Post Exhibition Planning Report

The purpose of this document is to provide a summary of the submissions received following the exhibition of the draft precinct planning documents for Riverstone West in March 2009.

**PROPOSED REDEVELOPMENT OF RIVERSTONE WEST PRECINCT
RESULTS OF FLOOD MODELLING FOR INDICATIVE LAYOUT PLAN**

Figure 8: Environmental corridor showing Core Riparian Zone, Vegetated Buffer and vegetation offsets.

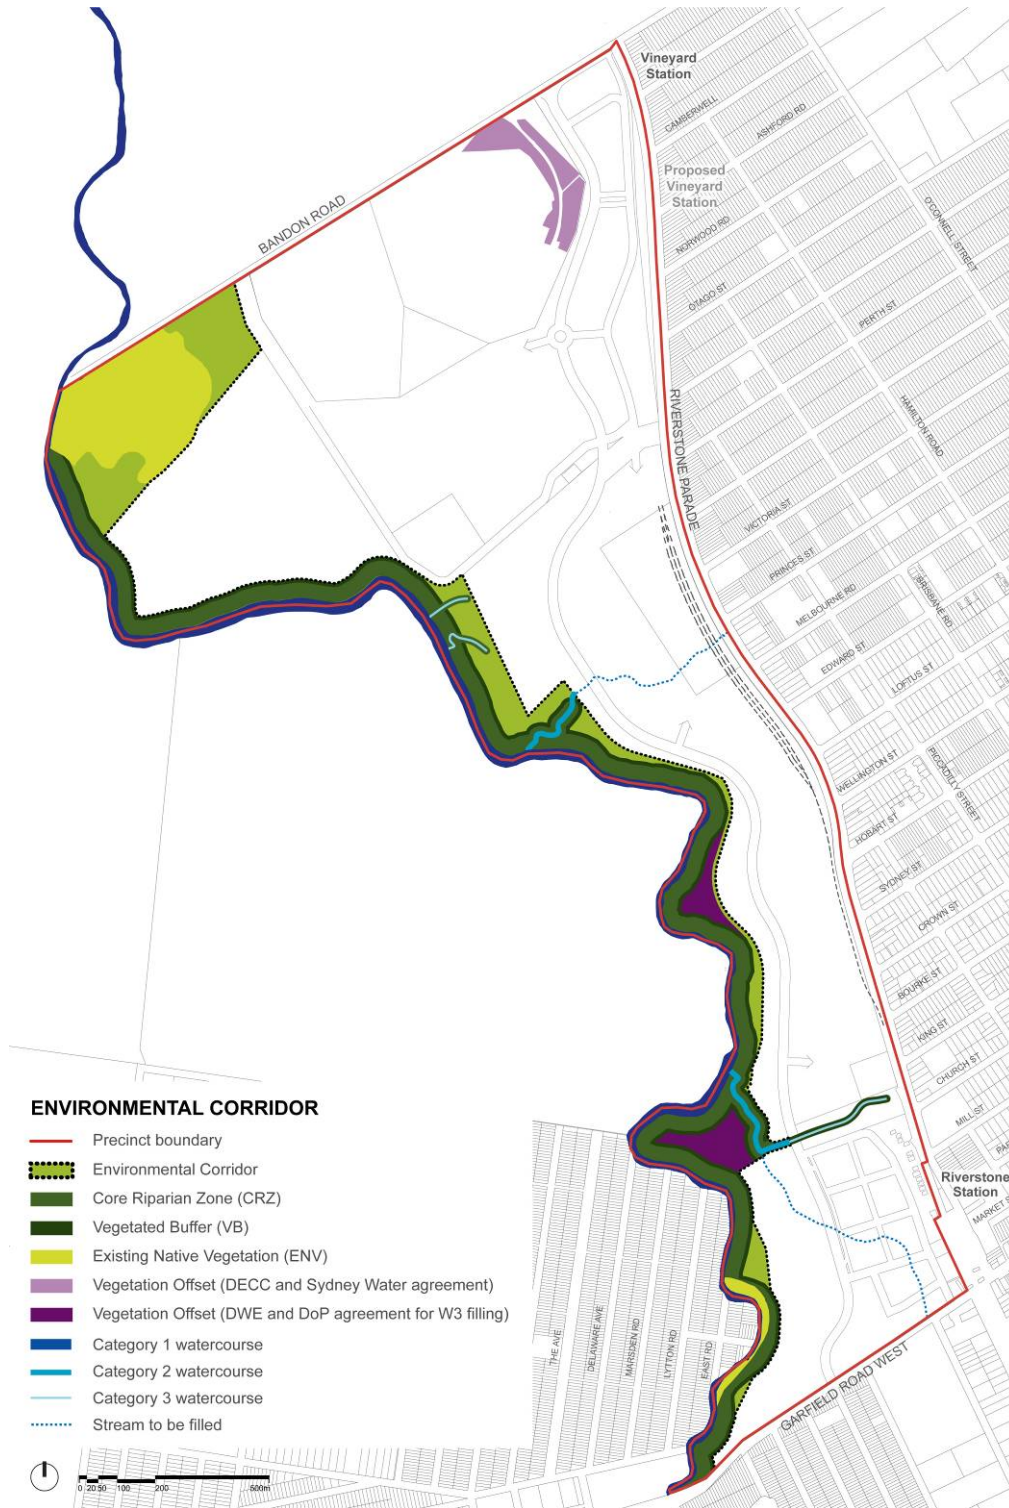
In response to DWE's request to distinguish the CRZ and VB from adjacent open space areas, Figure 26 of the DCP, showing the Riverstone West environmental corridor has been amended to clearly show the CRZ and VB within the environmental corridor. Uses appropriate within each of these areas are detailed in the NWGCWLS. **Figure 8** of this report provides further details regarding the vegetation offsets required by DECC and DWE.
